ADDENDUM #3

Project: No. 16-100
City of Owosso 2018 Façade Project CDBG Program
Owosso MI 48867

Architect: H2A Architects Inc.
9100 Lapeer Road
Suite B
Davison, Michigan 48423

Issue Date: July 10, 2018

A01-A03

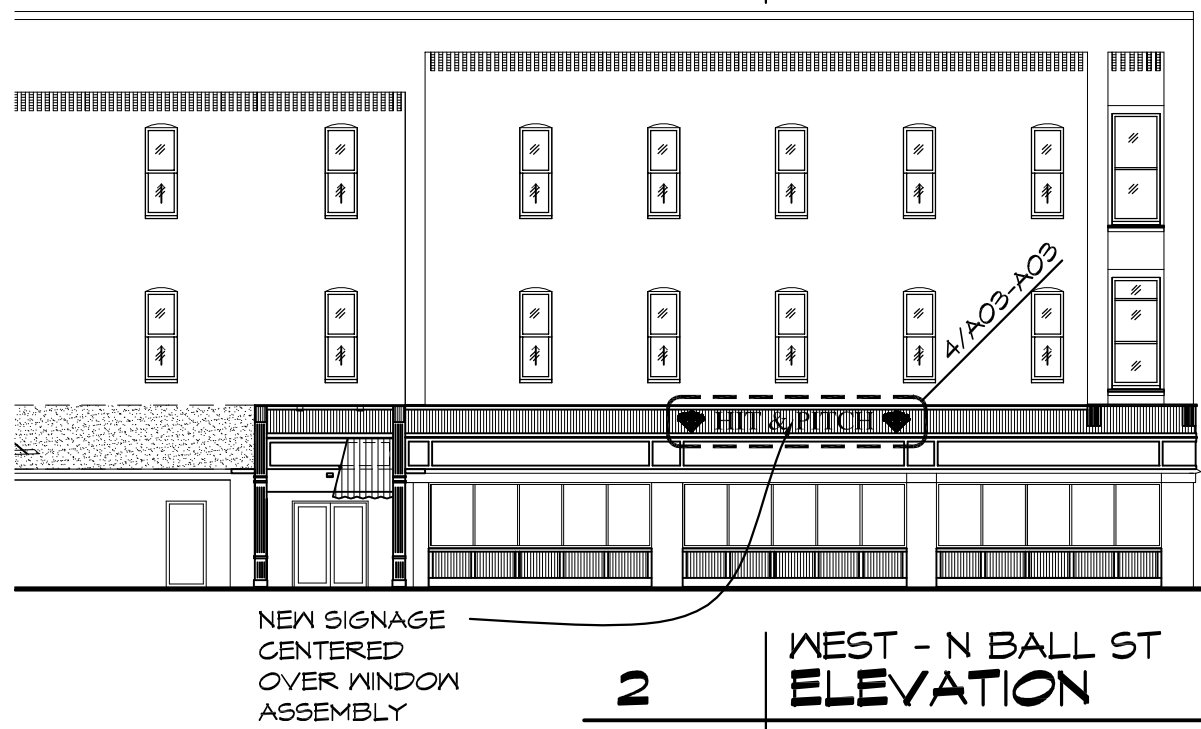
Item #2: Refer to 114 W. Main Street, Sheets A103, Detail 4, and Sheets A104, Detail 4:
Sheet A103: Title Reads: **West** – W. Main St Elevation, should read **South** – W. Main St. Elevation.
Sheets A103 and A104: Illustration indicates 'SIGNAGE BY TENANTS'. Project Signage for this project shall be part of the contract see attached sketches A01-A03, A02-A03 and A03-A03 for signage to be provided.

**SOUTH - W MAIN ST
ELEVATION**
